ITEM 5. DEVELOPMENT APPLICATION: YOUNG AND LOFTUS STREET BLOCK - NEW BUILDINGS - 2-10 LOFTUS STREET AND 16-20 LOFTUS STREET AND 9-17 YOUNG STREET SYDNEY**FILE NO: D/2015/930****DEVELOPMENT APPLICATION NO: D/2015/930****SUMMARY****Date of Submission:** 2 July 2015**Applicant:** AMP Capital Office and Industrial P/L**Architect:** Make Architecture, Silvester Fuller & SJB**Developer:** AMP Capital**Owner:** Kent Street P/L**Cost of Works:** \$122,293,200

Proposal Summary: Stage 2 integrated development application for the redevelopment of the Young and Loftus Street Block as part of the Quay Quarter development. The application is Integrated Development requiring approval from the NSW Office of Water under the Water Management Act 2000.

The development application is recommended for a deferred commencement consent.

Figure 19: Building A elevation – Stage 1 approved envelope in dotted line.

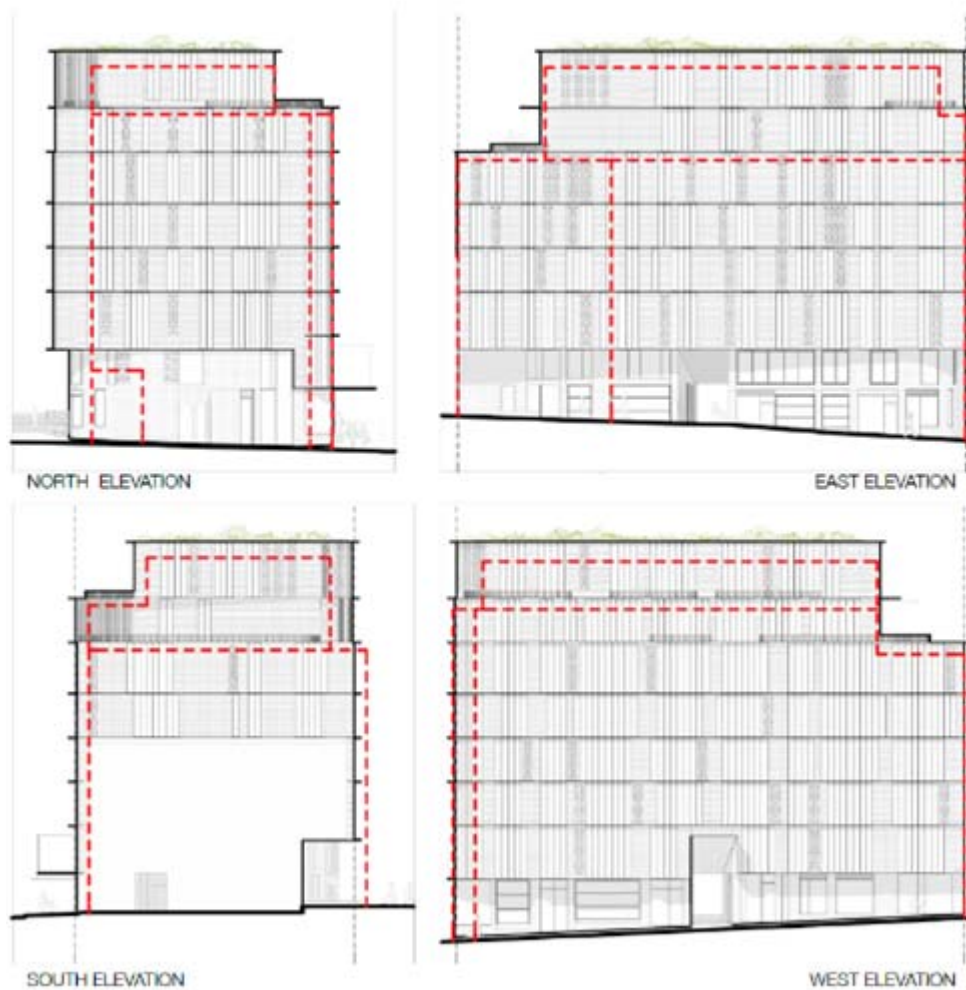
The additional height is related to balustrade heights required to provide a trafficable roof terrace. The increase is 1170mm as a solid element that acts as a balustrade and deep planter. The services and lift-overrun are hidden within the space (refer to Figure 19 below).

A height increase of 480mm on Level 7 and 430mm on Level 6 beyond the DCP envelope to provide a solid edge for planting and green roof for the terraces. An "open steel balustrade" setback from the buildings edge and sits above the DCP envelope by 930mm on Level 6 and 980mm on Level 7 (refer to Figure 15 below).

Figure 25: Visual privacy treatment features

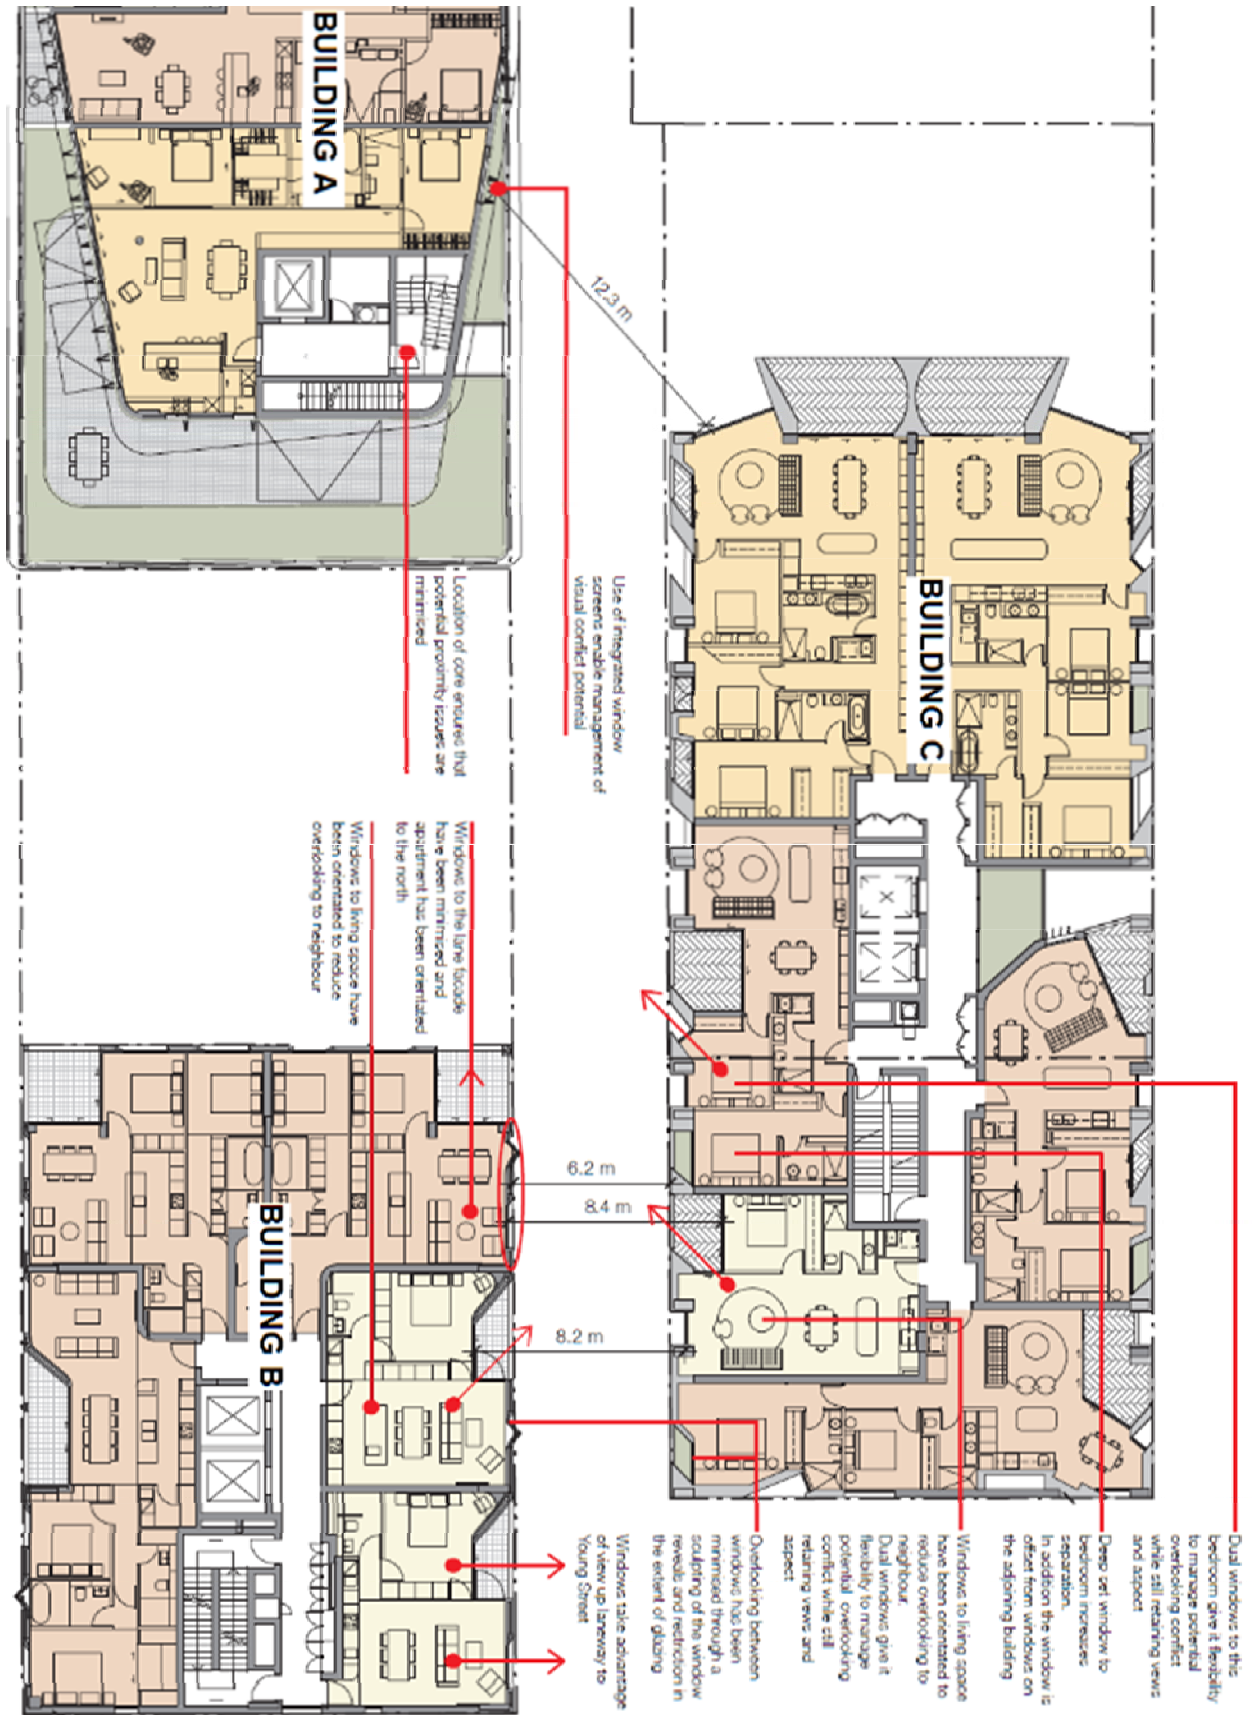
114. **Figure 25** below illustrate the apartments within Buildings A, B and C of the proposed development where the separation buildings is less than those recommended within the ADG and show the architectural design treatments proposed to reduce privacy and overlooking as discussed above.

115. As detailed in the Apartment Design Guide, degrees of privacy are also influenced by a number of factors including the activities or each of the spaces where overlooking may occur, the times and frequency these spaces will be used. In Building B (between gridline BC and BE), there is a single aspect apartment proposed from Levels 2-7. The primary outlook and balcony for this apartment directly overlooks the lane and Building C and the living room window of the single aspect apartment in Building C. Given this balcony is the only private open space allocated to this apartment the frequency of use will be high. It is considered that in order to achieve better visual privacy between apartments facing Loftus Lane that the 1 bedroom single aspect apartment facing Loftus Lane in Building B is deleted and amalgamated with the adjoining apartments to create larger floor areas and to alleviate visual privacy impacts across the laneway which already cannot comply with the minimum building separation requirements. As such, a design modification condition is recommended.

Figure 26: Proposed curved corner next to Gallipoli Memorial Club on Loftus Street

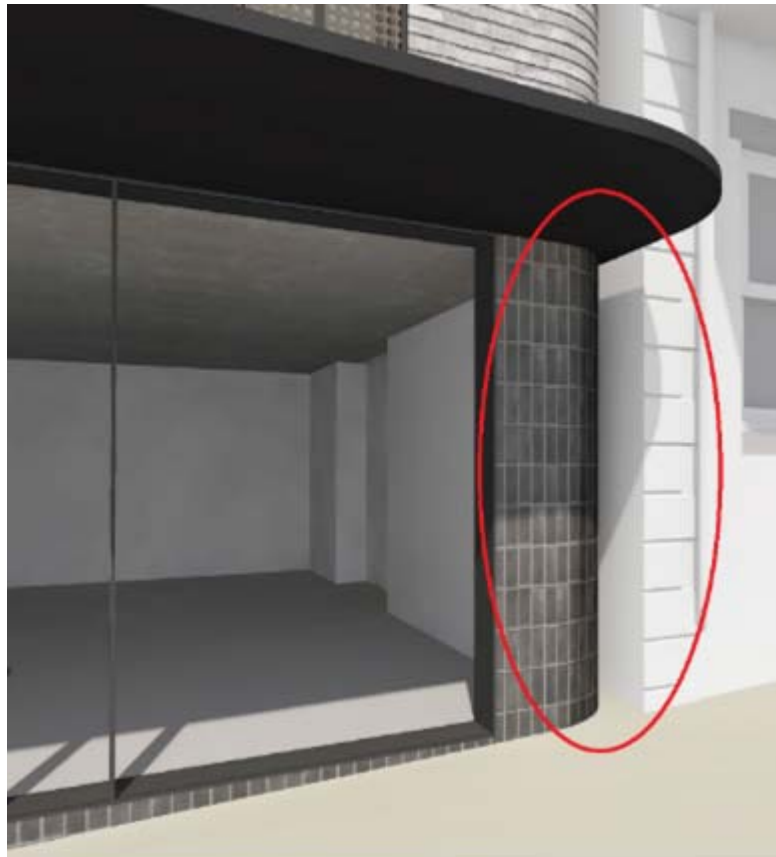
- (d) the proposed curved corner adjacent to the Gallipoli Memorial Club is justified on the basis of the curvatures of Booth House and Custom House and revealing the side of the heritage item (refer **Figure 26** below). This side was never meant to be revealed being part of a once extensive row. The space formed by the curvature will recede to a point where it will not be possible to tool the brickwork. The space is likely to collect dust and rubbish. A shallow square recess would be a more buildable solution.

Figure 28: Proposed at grade loading dock/designated waste collection area

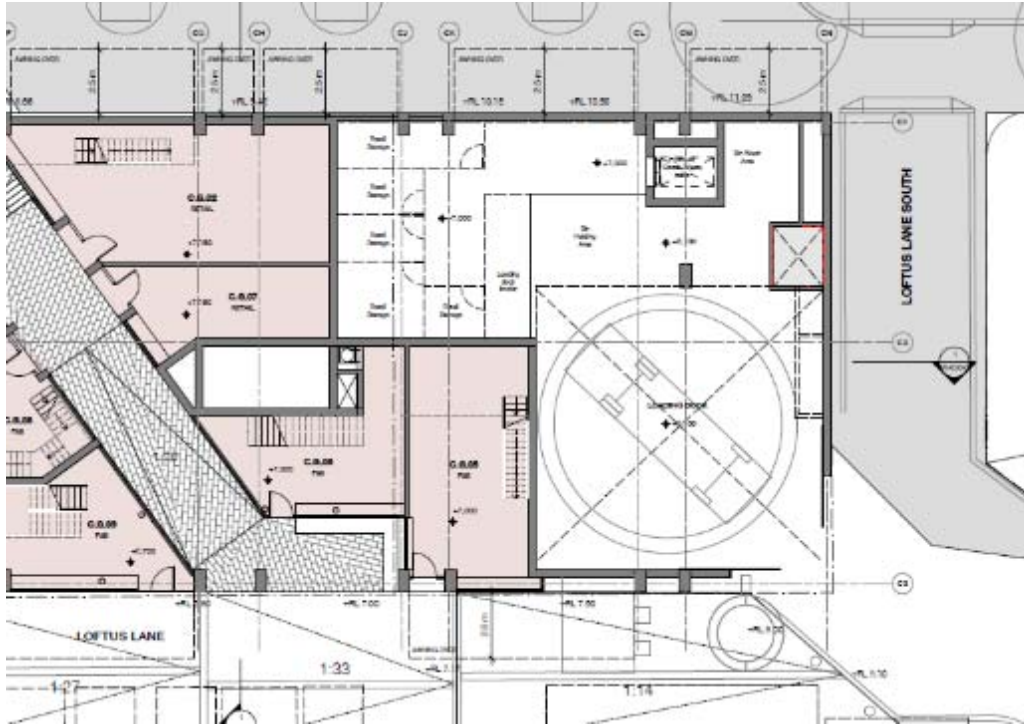
132. It is acknowledged that the site is limited as to where vehicle access to the site can be permitted; Loftus Lane north-south is to be pedestrian only and due to the gradient of the site and Bennelong Stormwater Channel bisecting the site vehicle access off Loftus Street and Young Street is limited. The applicant has investigated options for ramp access to the basement level via Loftus Lane south east and found this option to be unviable in order to obtain an appropriate and safe gradients for a Council garbage truck and large service vehicles.

133. The application proposes a dedicated at grade loading dock/collection bay within Building C (south western corner of Loftus Lane 9-17 Young Street building) and includes a turning circle which is able to accommodate a Council garbage truck. Service vehicles will be via Loftus Lane from Loftus Street and all deliveries and servicing will take place within this loading dock and will take place on a turntable so that all service vehicles will be able to enter and exit the premises in a forward direction. A Loading Dock Management strategy will be put in place to ensure coordination of all delivers so that there are no queuing of vehicles within the Lane.
